Access Compliance Report Public Rights-of-Way (Curb Ramps)

Main Street: HEWES_ST Cross Street: E_EUCLID_AVE Location: SW

ADA ID: RPAT210928134439 Ramp Type: Type 1 - Perpendicular Diagonal Initial Pass/Fail: Fail Overall Compliance: No Severity Score: 2

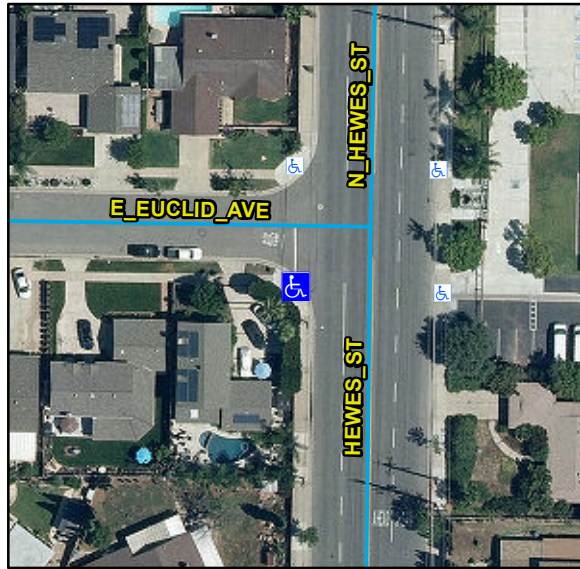
R304.2.2, R304.5.3, STD 1115

Remove & Replace Curb Ramp With Two New Directional Ramps or Equivalent.
